**Project Name: Village Apts Phase III**

**Project Location: 82 Jerome Rd, 15 Jerome Ave & 232 Rt 32**

Reviewing Agency: Fire Marshal

Review Date: 1/25/22

INFERNO 167 AERIAL - TURNING RADIUS DIAGRAM

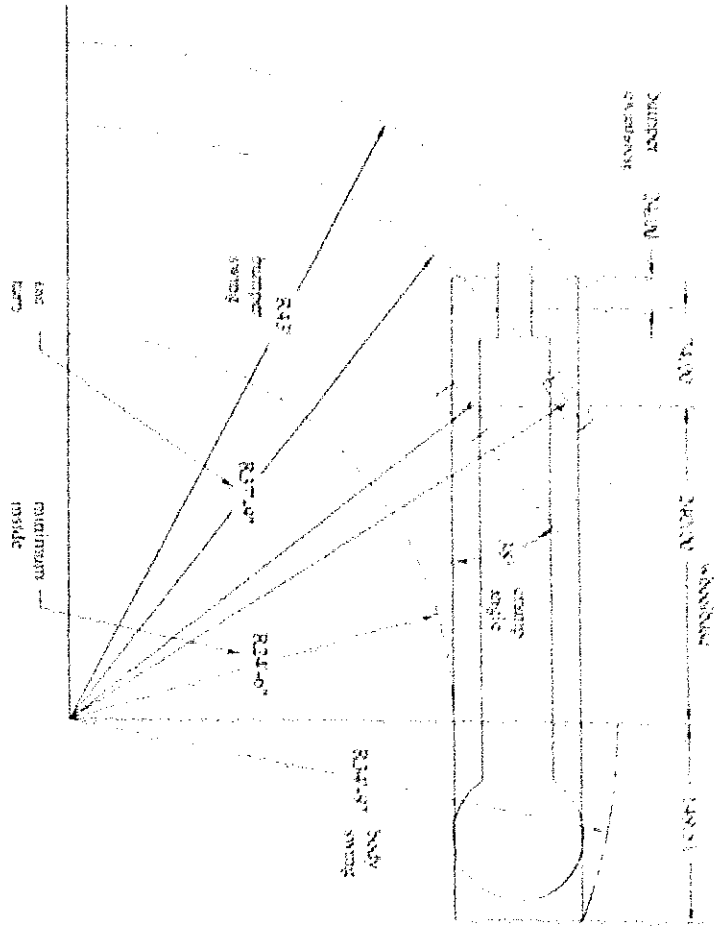
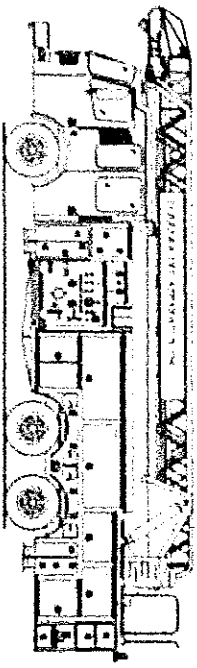
Notes: SHEET 5 Bldg A+B Horse shoe parking/driveway NOT enough turning radius for FD ladder truck. 43' bumper swing.

JEROME AVE ENTRANCE TO Bldg C NO ADEQUATE TURNING RADIUS FOR FD LADDER TRUCK. 43' BUMPER SWING
